SUBJECT: PEACH BOTTOM ATOMIC POWER STATION, UNITS 2 AND 3 - ISSUANCE
OF AMENDMENT RE: 1.62% INCREASE IN LICENSED POWER LEVEL
(TAC NOS. MB5192 AND MB5193)

PEACH BOTTOM ATOMIC POWER STATION, UNIT 2

Amendment No. 247
License No. DPR-44

Amendment No. 250
License No. DPR-56

Figure 3.4.1-1 (page 1 of 1)

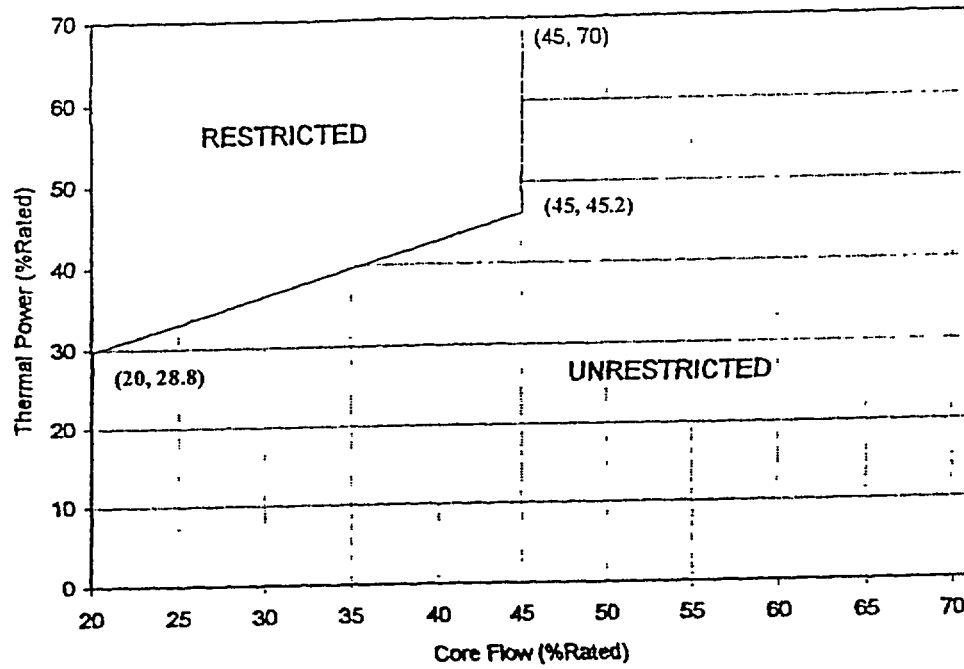
These amendments increase the licensed power level by approximately 1.62% from 3458 megawatts thermal (MWt) to 3514 MWt. These changes are based on increased feedwater flow measurement accuracy achieved by utilizing high accuracy ultrasonic flow measurement instrumentation.

Figure 3.4.1-1 (page 1 of 1)

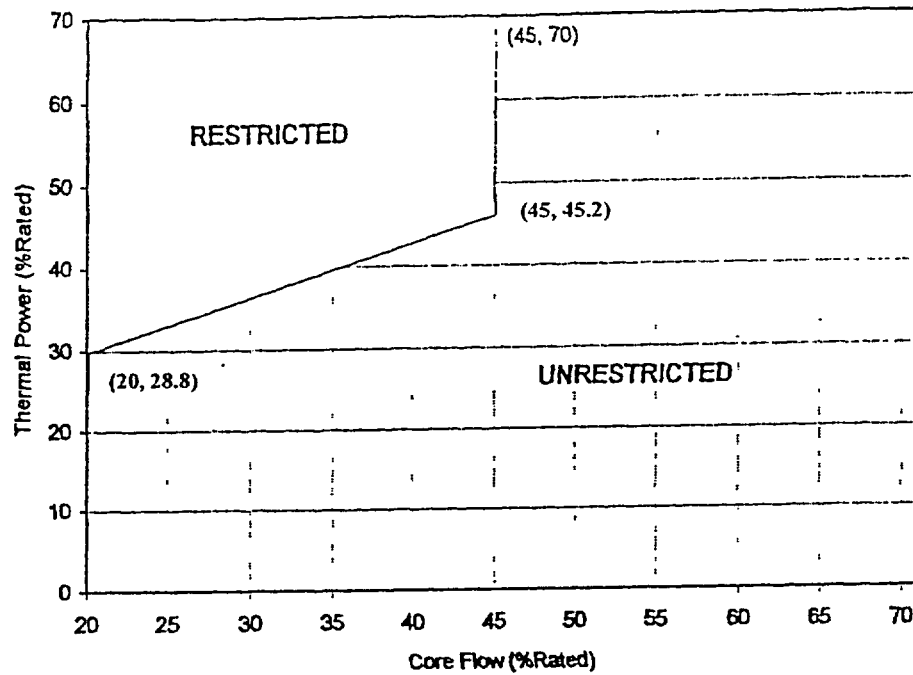
These amendments increase the licensed power level by approximately 1.62% from 3458 megawatts thermal (MWt) to 3514 MWt. These changes are based on increased feedwater flow measurement accuracy achieved by utilizing high accuracy ultrasonic flow measurement instrumentation.
